SOUTHEASTERN WISCONSIN REGIONAL PLANNING COMMISSION

MEMORANDUM

SUBJECT: SOUTHEAST WISCONSIN 2015 LIDAR (SEWI_5)

Appendix

Milwaukee County – NAD27 / NGVD29

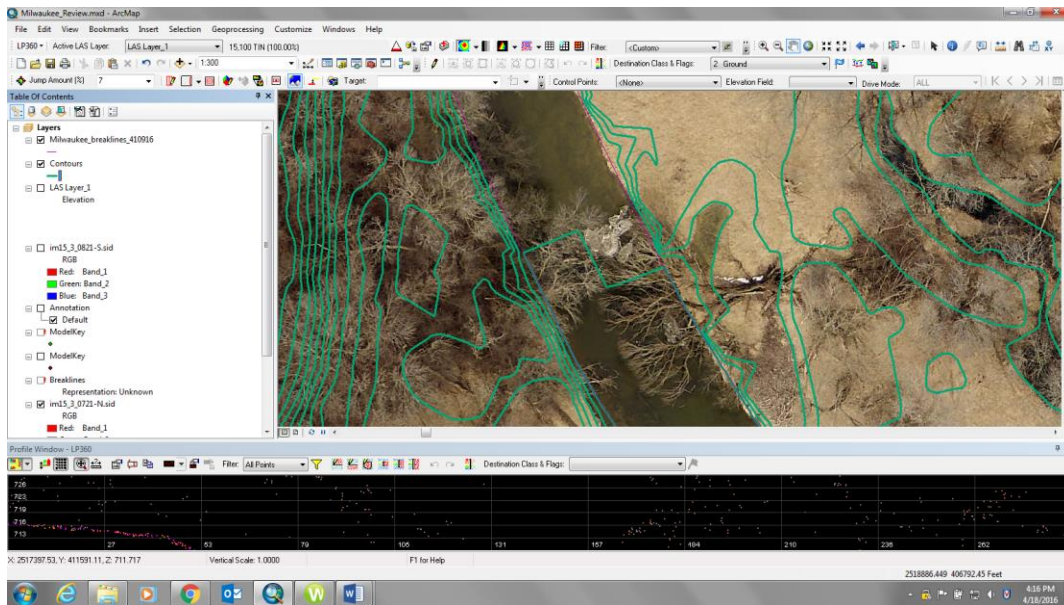
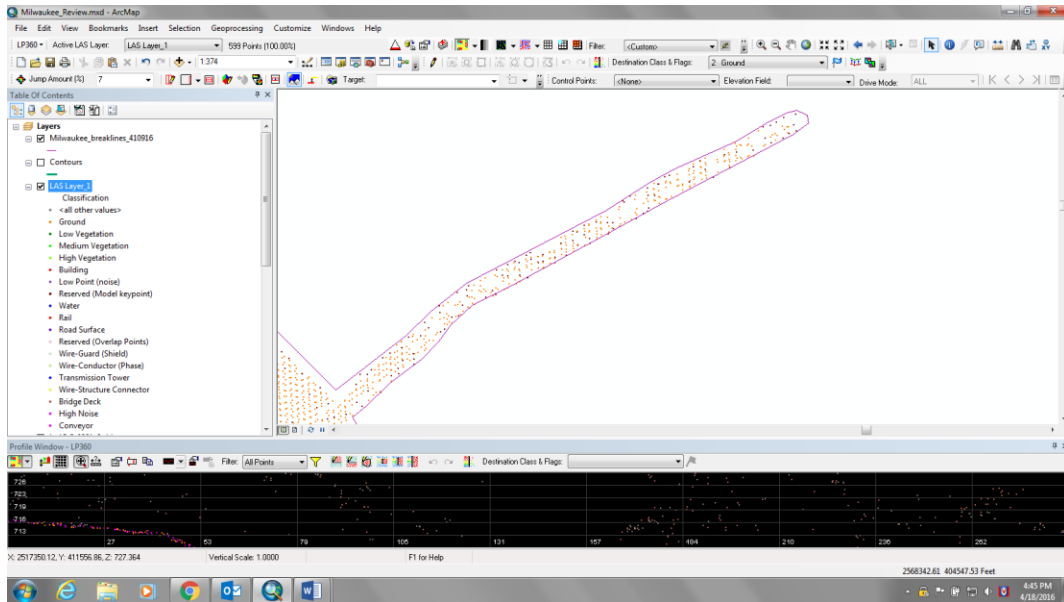
Points outside of breakline. Shoreline has points cleared but the breakwater wall did not have any points cleared away from breakline.

ND83/2011 TILE (Id15_BE_2460_450_NAD83-2011.las)

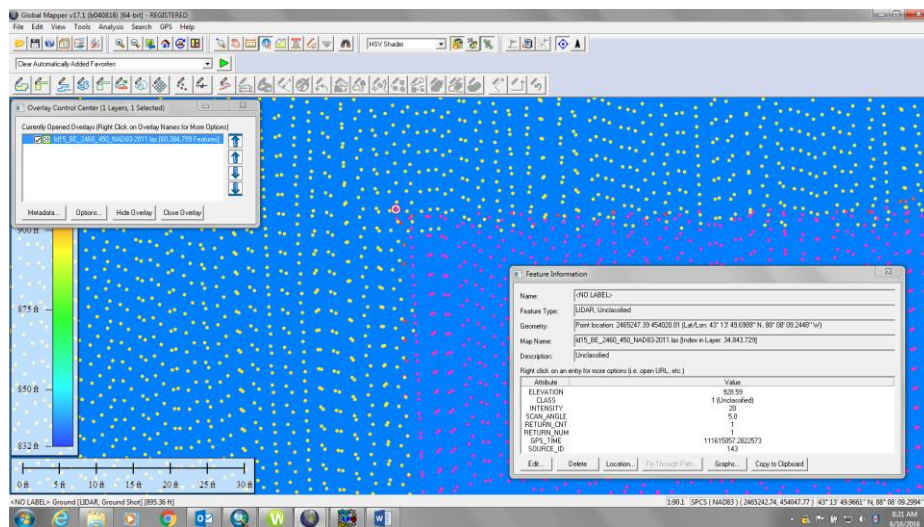
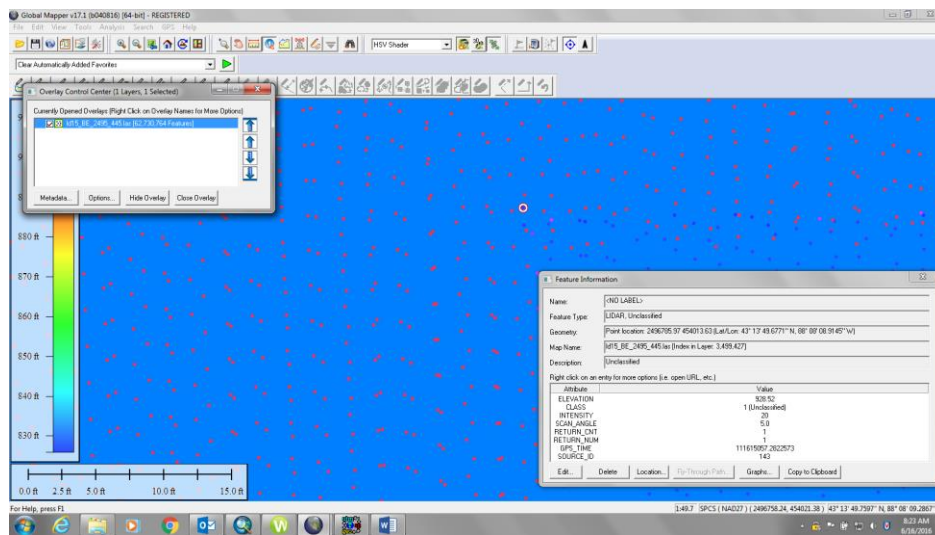
Converting from NAD83/2011 to NAD27, the sample point computed found is inconsistent between datums:

NAD83/2011 NAVD88	NAD27 NGVD29	Corpscon (83HARN to 27; 88 to 29)	Corpscon (83 to 27; 88 to 29)	Delta- Corpscon HARN to Pub. 27/29	Delta- Corpscon to Pub. 27/29
454,020.81	454,013.63	454,012.638	454,013.608	-0.992	-0.022
2,465,247.39	2,496,785.97	2,496,785.322	2,496,785.977	-0.648	+0.007
928.59	928.52	928.82	928.820	+0.300	+0.300

NAD83/2011 Tile (Id15_BE_2380_440_NAD83-2011.las)

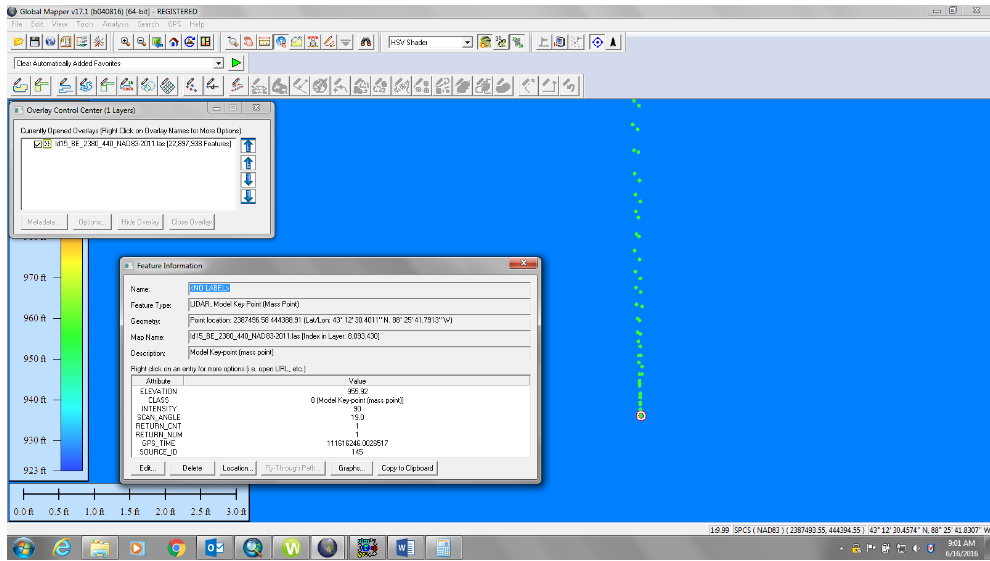
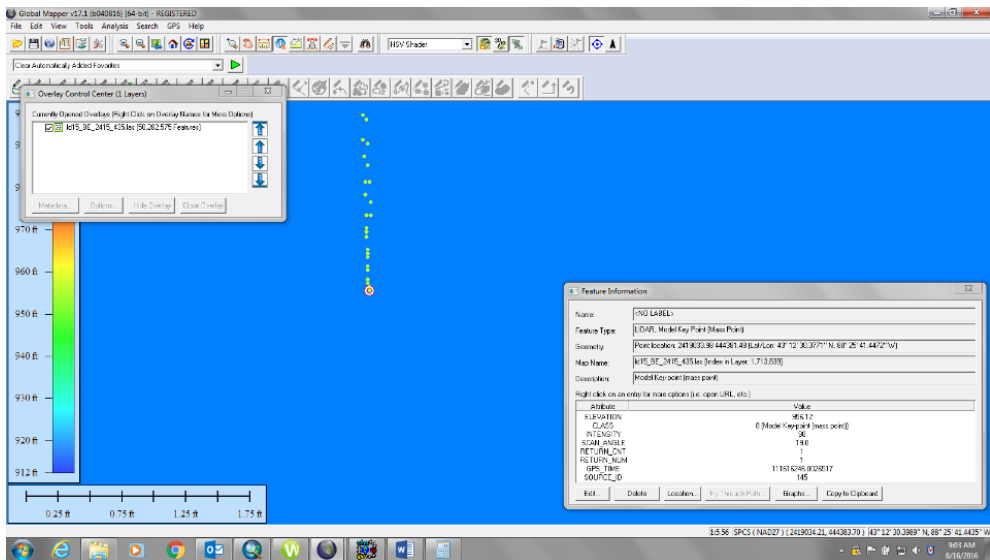
Converting from NAD83/2011 to NAD27, the sample point computed found is inconsistent between datums:

NAD83/2011 NAVD88	NAD27 NGVD29	Corpscon (83HARN to 27; 88 to 29)	Corpscon (83 to 27; 88 to 29)	Delta- Corpscon HARN to Pub. 27/29	Delta- Corpscon to Pub. 27/29
444,388.91	444381.48	444,381.466	444382.296	-0.014	+0.830
2,387,496.58	2,419,033.98	2419033.985	2419034.551	+0.005	+0.566
955.92	956.12	956.117	956.117	-0.003	-0.003
